. City of Portland, Maine - Building or Use Permit Application 389 Congress Street, 04101, Tel: (207) 874-8703, FAX: 874-8716 Location of Construction: Owner: Phone: Permit No: 9 Portland Pier Steve McDuffie work 773-7206 Owner Address: Lessee/Buyer's Name: Phone: BusinessName: Wellwood Parnership, 230 Anderson ST, Portland, 04101 Permit Issued: Phone: Contractor Name: Address: COST OF WORK: Proposed Use: PERMIT FEE: Past Use: \$3,000.00 \$42.00 FIRE DEPT. Approved INSPECTION: Commercial Same Use Group: 7 Type: 1 ☐ Denied CBL: 030-н 011 Signature: Proposed Project Description: PEDESTRIAN ACTIVITIES DISTRICT (P.A.D.) Action: Approved П New entry doors, new fire exit & install 2 particians Special Zone or Approved with Conditions: interior - 4th front □ Shoreland Denied □Wetland ☐ Flood Zone Signature: Date: □ Subdivision ☐ Site Plan maj ☐minor ☐mm ☐ Permit Taken By: Date Applied For: Gay1e August 21, 2000 GG **Zoning Appeal** □ Variance This permit application does not preclude the Applicant(s) from meeting applicable State and Federal rules. ☐ Miscellaneous Building permits do not include plumbing, septic or electrical work. ☐ Conditional Use PERMIT ISSUED Building permits are void

NEW WORK SHOWN IN BOLD

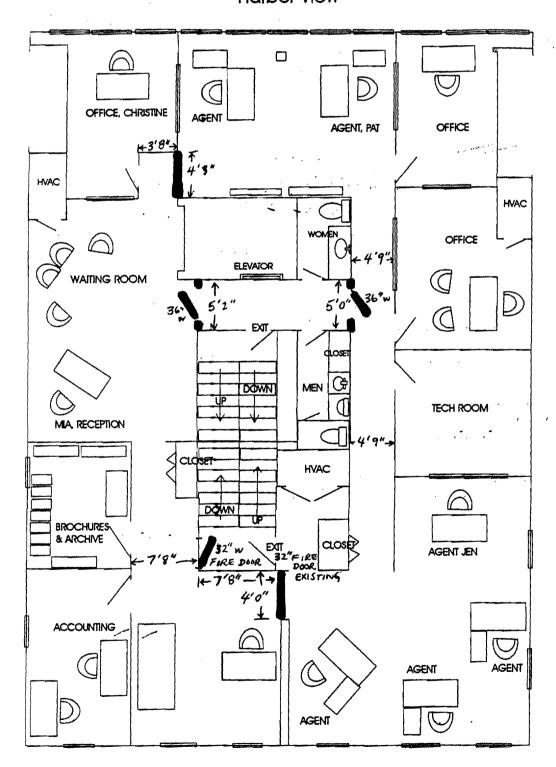
9-13-00 fre-con co/ Jim - Need to be advised by MAC as to The Fire separation requirements or The Access to The Stairwell and separating one business into 2 spaces. 82 9-22-00 Met w/ Mia At Accent Travel to assess Egress routes - still need to verify
COPILISOMENTS by To Access to The Stairwell and Something one business into > smear VB
9-22-00 Met 11 Mis at Arcount Travel to access source pourtes - ctill and to inquis
I what
w/MAZ
9-25-00 reviewed Jams w/ MTC, because of same use group The 15 toot interconnecting
9-25-00 reviewed Dans w/ MAZ, because of same use group The 15' Foot interconnecting hall does not need here doors since There is here protection around elevator and
egness stairwell 823
Inspection Record
Type Date
Foundation:
Framing:
Final:
Other:
